Australian Technology Park Redevelopment SSD 7317

Submission to NSW Planning and Environment
9 March 2016

City of Sydney

Figure 3. Extent of Building 1 height non-compliance shown in unshaded building envelope relative to maximum height limit and adjoining child care centre
Source: Proponent's SSD Application

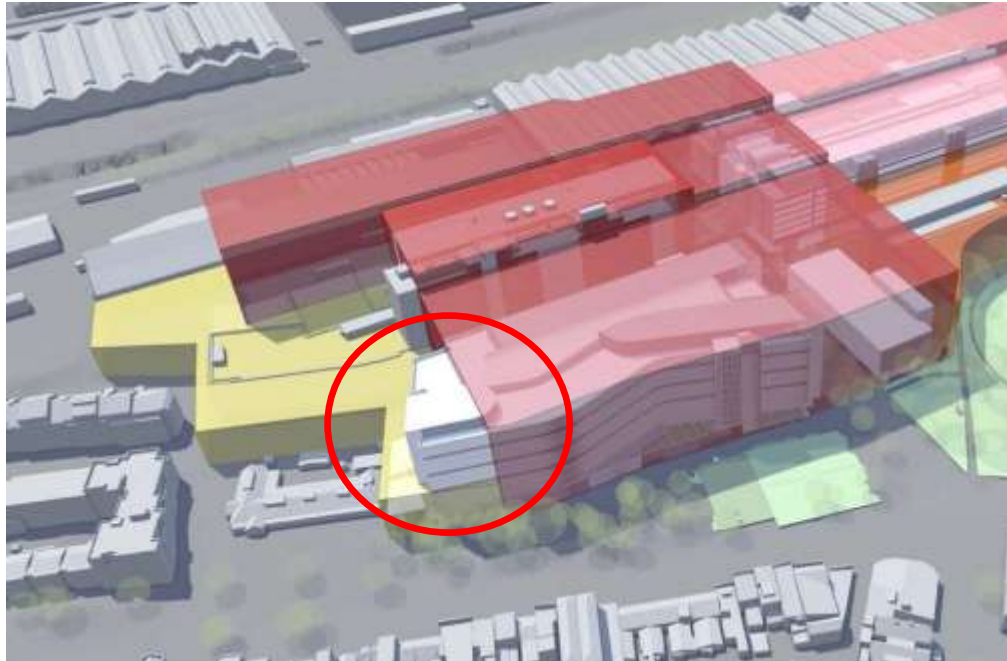
The proposed non-compliance with the building height standard in State Environmental Planning Policy (Major Development) 2005 is not well-founded and cannot be supported. The development is easily capable of achieving compliance with the legal planning controls and the commercial objectives sought through redistribution of heights and/or reallocation of GFA between buildings.

The impacts are unacceptable from non-compliance and impact the single storey Alexandria child care centre, 3-5 storey private and public housing to the west and 1-2 storey terraces to the south.

The addition of a second tall building, following the Media City construction, alongside the child care centre will have significant visual impact on the playground, overshadowing of the playground in the morning period and a contribution to a real sense of enclosure. The non-compliance, coupled with an at-grade car park immediately alongside the playground, eliminates any ability of the proposal to be screened by landscaping to soften its appearance.

The additional bulk and scale of the building at the western edge results in adverse additional overshadowing of properties along Henderson Road, many of which would not be overshadowed at all with a compliance scheme and many of which would get afternoon relief from overshadowing with a compliant scheme.

Building 1 must comply with the building height standard in the Major Development SEPP.

The existing 4-storey height control should be stayed and Building 1 height reduced from 9 storeys to 4 storeys by redistribution of GFA to create a more appropriate scale shift to development to the west and reduce overshadowing and visual impacts on surrounding properties to the west and south.

Figure 6. External car parking results in poor interface with child care centre
Source: Proponent's SSD Application

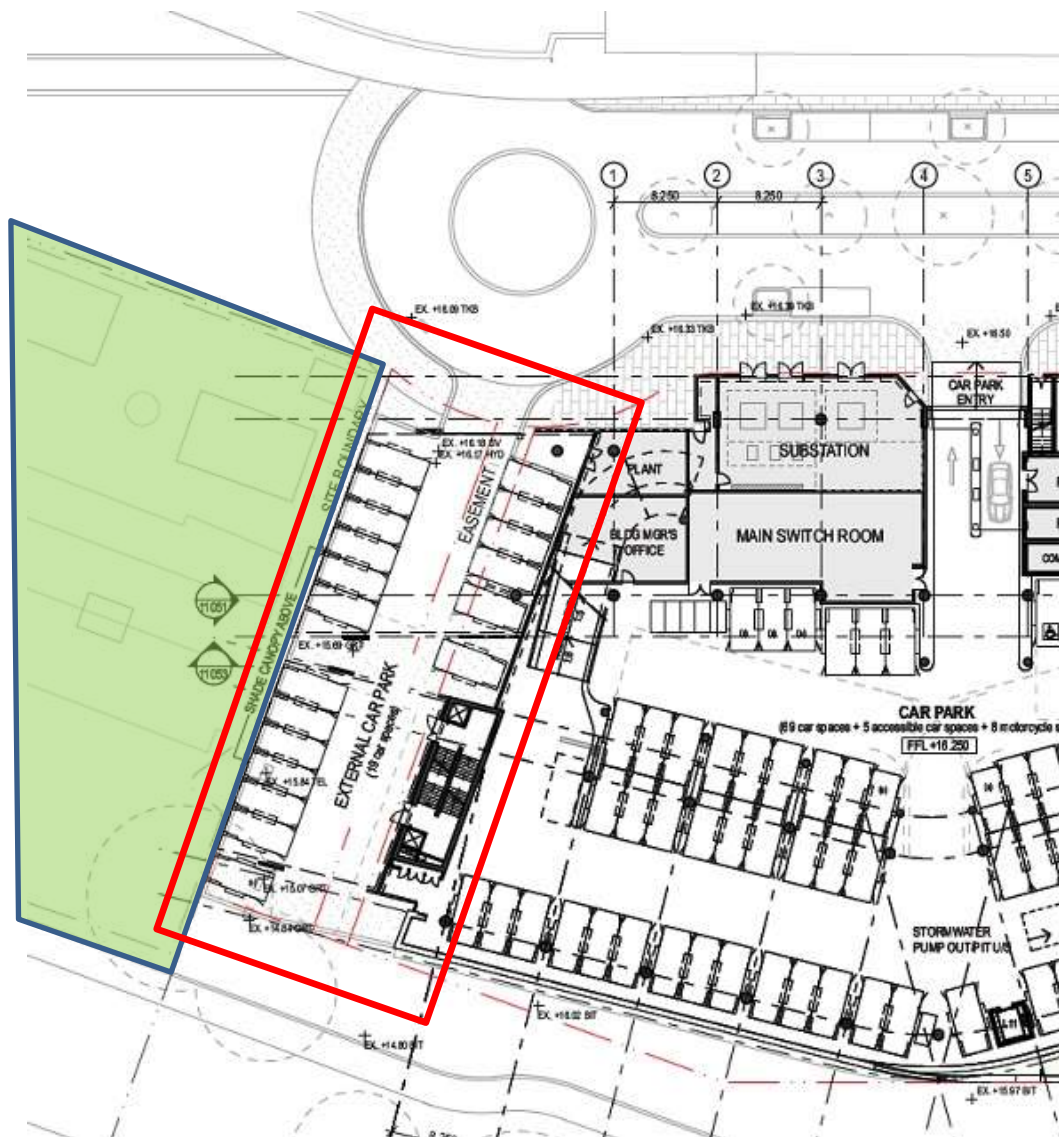
A landscape setback is required to the western boundary of Building 1 alongside the child care centre. The design must remove the external car park and the shading structures at the boundary. The interface should be planted out with mature trees.

Incorporate a landscaped setback to the adjoining child care centre by deletion of the external car parking and shade structures and mass planting.

Figure 7. Extract of Building 1 floor plan showing design of child care centre outdoor space
Source: Proponent's SSD Application

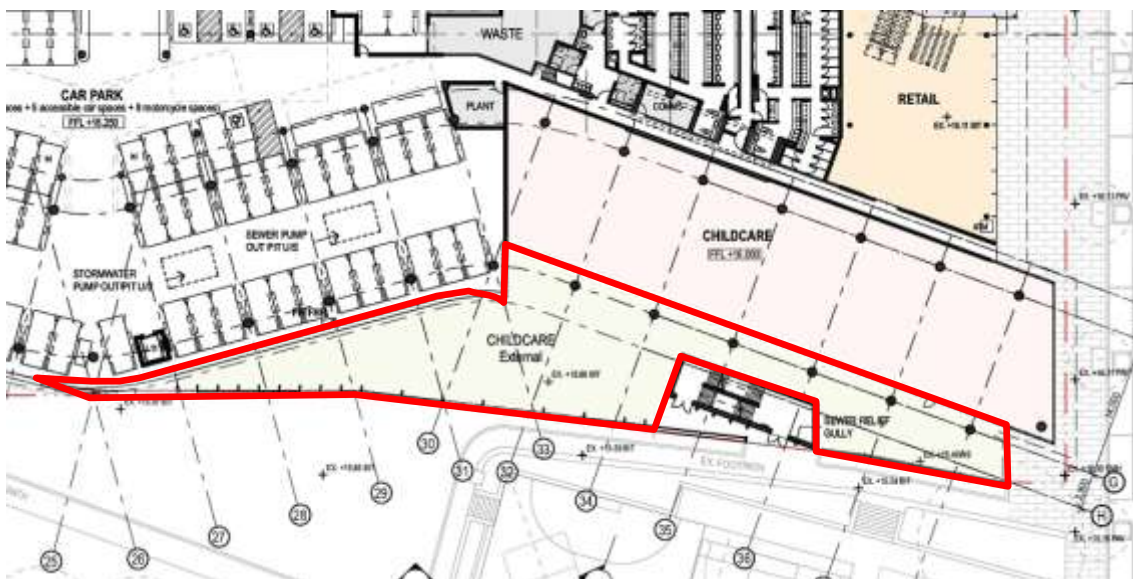
The design for the child care centre outdoor space within Building 1 lacks sunlight, usable area, clear sight lines for carer surveillance and may be affected by poor air quality from the open car park area adjacent. The ends are narrow, the fire stair core intrudes into the most useable space and the position is along the southern elevation with no prospect of sunlight. More of the outdoor area should wrap the south-eastern corner into Davy Road and the stair core and openness of car parking requires re-examination.

The external space of the child care facility in Building 1 requires redesign to address useability, access to sunlight, air quality and surveillance.

Figure 8. Community Building has a poor interface with Vice-Chancellor's Oval and proposed play space

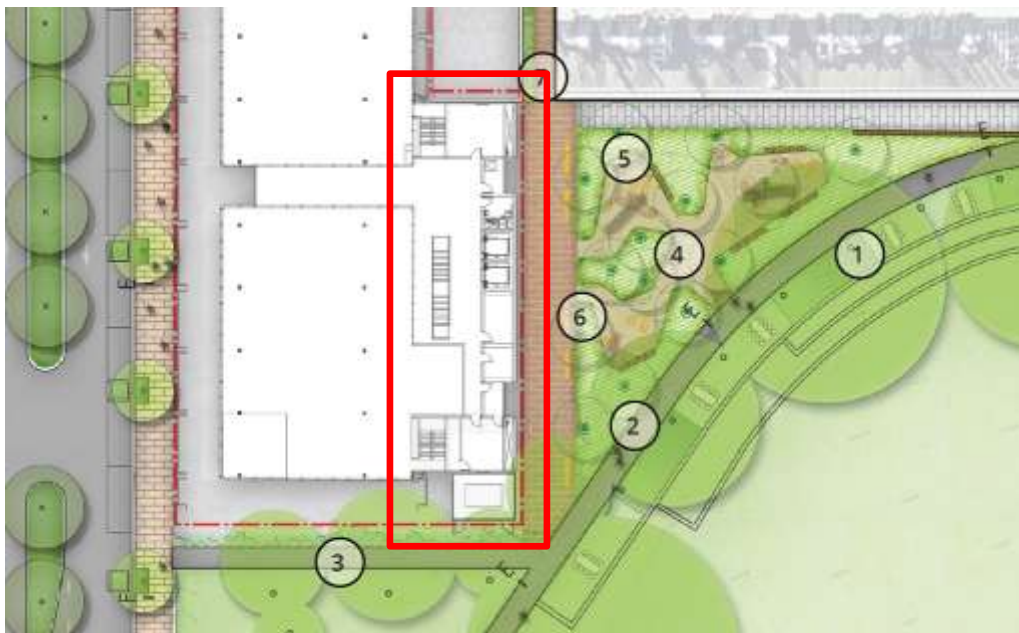
The ground floor of the Community Building proposed a gym and retail space along Davy Road and at the south-western corner. However, the south-eastern frontage has a kiosk substation and a series of services/plant rooms facing the Vice-Chancellor's Oval/Eveleigh Green. The proposed remodelled Oval / Green has numerous areas for seating, lunch breaks and active recreation including an "intimate play space" with nature play elements, seating and sensory planting immediately alongside the Community Building.

The design results in poor relationship with the open space and lost opportunities for gym users to interact with the open space and passive surveillance of the open space, especially late at night as the gym is proposed to be 24 hours a day.

Redesign the south-eastern corner of the Community Building to wrap gym or retail active frontage toward Vice Chancellor's Oval and proposed play space.
